**MINUTES OF THE MEETING  
March 20, 2008**

**Seattle  
Design  
Commission**

**20 March 2008**      **Project:** **Capitol Hill Station ST University Link**

**Phase:** Design Development

Figure 7: Art piece

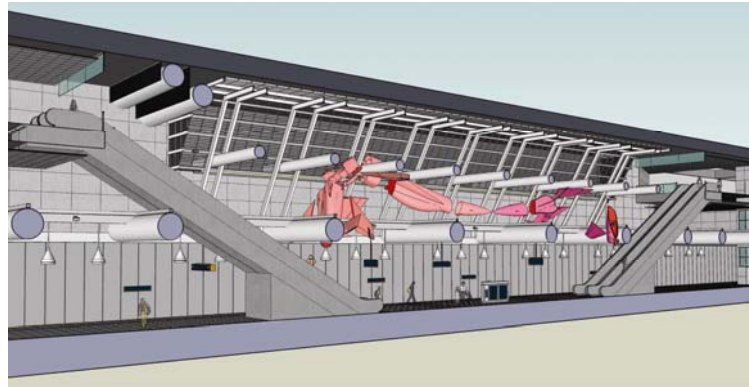
- **The materials palette seems reserved and somewhat institutional and may benefit from a more dynamic color scheme.**
- **Some panel members expressed a concern for the use of warplanes in art piece in the context of a light rail station. While we appreciate the artist's intention of expressing fluid movement and natural forms, the relationship between natural form and a fighter plane as presented is questionable. A solution may be an artist statement prepared for the next presentation to clarify the appropriateness of the art in the station.**

- Other ways planes penetrate architecture that is not so offensive?
  - Urge great care in emphasizing poetry of forms in people's minds. Notion of destruction is there in the fighter jets, but the entire form after deconstruction of the pieces is holistic. The piece is not meant to convey aggression.

- Appreciate the element of tension in the public art, which is scarce these days.
- Fact that it is a fighter jet may stop some people from interpreting it as art.

- Love the idea of the pink muscular object. Could emphasize the nature and poetry side of the piece more.
- Appreciate interpretation of tunnel space as descending through clouds.

- Chosen a provocative art piece. Planes may be appropriate with everything that is going on in area and the neighborhood.
- Concern over violent ramifications of art piece. Appreciate that the art seeks to connect important "Seattle qualities" of nature and technology into this piece, but question the use of a fighter jet as the manifestation of those ideas. Encourage further reflection on this, and preparation of an artist's statement for review next time.

- How far above the ground are the large braces?
  - 15 feet high and 6.5 feet in diameter.
- Appreciate muscularity of structure.
- What is the floor surface?
  - Tiles. Need to take the sight impaired into account. Have chances for contrast between 'ribs' and art piece.
- What are the sides of the tunnel?
  - Won't see through to the lighting. Will be a balance of materials
- How does the station deal with the noise?
  - The concrete structure above the perforated ceiling panels will be sprayed with acoustical insulation.
- Appreciate the showcase of space and the inclusion of the art in the space.
- Why fighter jets?
  - The jets convey the sense of strength and power, and the peace that happens after war. There is no tension with other types of planes, or

aesthetic interest. The piece gives grace and femininity to the strength and masculinity of the planes.
